Category <b>U</b>	<b>Technical</b>	Ref. No. E033/05	Page 1 of 2
Coverage <input type="checkbox"/> Distributor only <input checked="" type="checkbox"/> Please inform your dealers		Date Issued December 20, 2005	
Please convey this information to your <input type="checkbox"/> Director <input checked="" type="checkbox"/> General Manager <input checked="" type="checkbox"/> Warranty Dept. <input checked="" type="checkbox"/> Parts Dept. <input checked="" type="checkbox"/> Training Dept. <input checked="" type="checkbox"/> Field Rep.		Date Revised	
Applicable Models  RX-8 (FE / SE)		Applicable Countries or Specifications  US & EC Spec.

## Subject: Protector Set for A/C Condenser

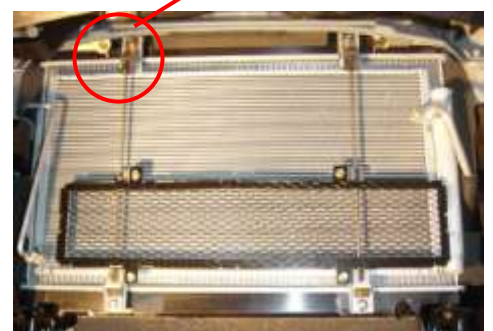
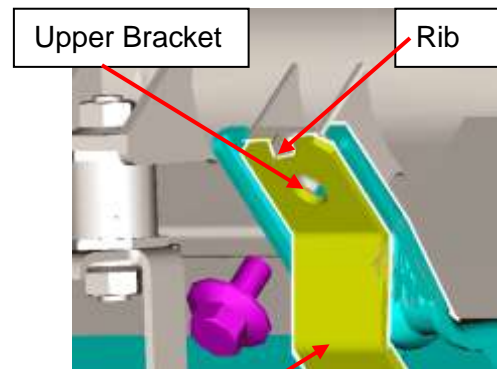
In order to protect the A/C condenser from damage caused by stones kicked up while driving, a protector set has been established.

1. Remove the under cover.
2. Remove the bolts from the A/C condenser.
3. Install a protector in the condenser of the radiator.  
Note: Align the cut portion of the upper bracket and A/C condenser to the rib of the radiator, and then tighten the bolts.
4. Reinstall the under cover.
